# BVLOS Trial in Unsegregated Airspace

Remotely Piloted Drone Flight Trial Documentation:  
Annex D Engagement Feedback  
ACP-2024-001

Document version:  
V1.0

Figure 1 Google map (extract ©) showing Slains Castle in relation to the proposed TRA

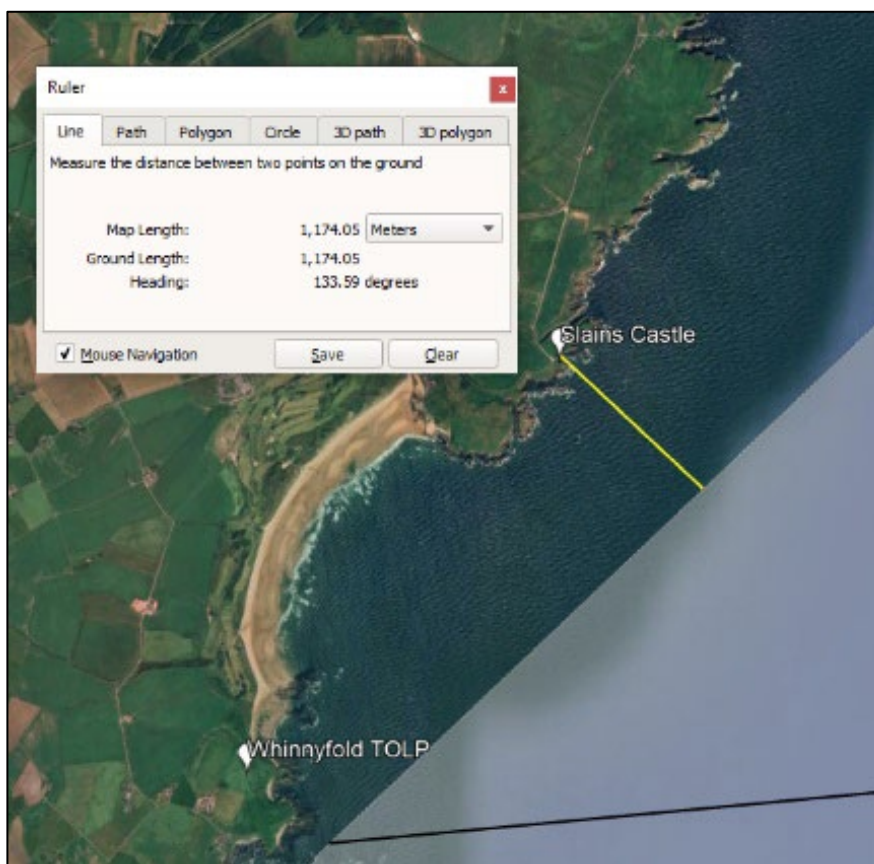
6.8.1 Buchan Aero Club requested an adjustment to part of the proposed TRA to provide 500m gap between the TRA boundary and Northeast of Cruden Bay. The reason is to provide sufficient gap for any GA aircraft to remain outside the TRA and have a clear view of Slains Castle ([link](#) to Google map), reducing the impact on GA aviation.

6.8.2 We clarified their request by providing detailed map and showing that the proposed TRA design has 0.64NM/1.2km gap between TRA boundary and Northeast of Cruden Bay. Buchan Aero Club representative acknowledged that the gap will be sufficient for manoeuvring for such flights.
